Ducted Systems Technical Services: Service Tips Letter

Letter: ST-022-22

Subject: **Simplicity Controller Solder Trace Failures**

Product/s: **Light Commercial Simplicity Controllers (Lite and 1A Controllers Only)**

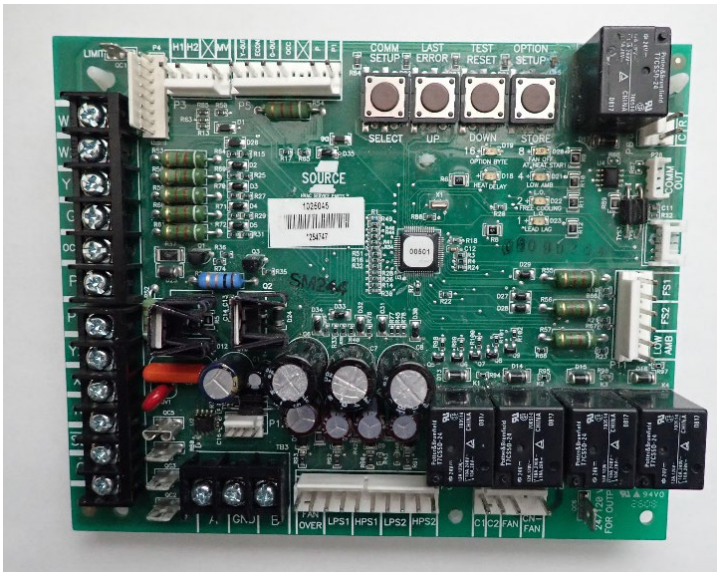
If a controller solder trace has failed from the W1 or W2 thermostat input to their H1 or H2 output, certified HVAC Technicians are authorized to bypass the controller and utilize a field-supplied single-pole single-throw relay. This type of failure must be verified using an ohm meter between W1 to H1, or W2 to H2 terminals with wires and harnesses disconnected (the meter should read an open circuit). Once verified the circuit is open, the resolution below is authorized **only for temporary use in the heating mode**.

To install the relay, certified HVAC Technicians will need to field supply wire for the thermostat's W1 wire termination, H1 wire, and tap into the 24v output terminal of the equipment's factory-installed stepdown transformer. (All voltages should be confirmed with a voltage meter before wiring to ensure only low voltage is being used). In addition, standard industry safe electrical work practices must be followed, and the system should be de-energized with appropriate Lockout-Tagout precautions at the power source.

To wire the relay, certified HVAC technicians should field wire splice into the 24v of the transformer and splice into the H1 or H2 output wire, and attach them to the contacts of the relay. Then an additional field-installed wire should be spliced into the board's W1 or W2 and the transformer's grounded common wire of the secondary side. These wires will be attached onto the coil of the relay to allow operation of the heating mode. (The same process can be used for W2 to H2 solder trace failures) **Note: During this process, the thermostat should be sending the W1 or W2 signal to the thermostat terminal on the simplicity controller and the relay at the same time to ensure fan operation.**

Material: S1-02421678700 Description: RELAY, CNTRL,24V,50/60 HZ, SPST

Field Wiring Specifications: 18 AWG stranded wire, minimum thermal rating of 105°C, rated VW-1.
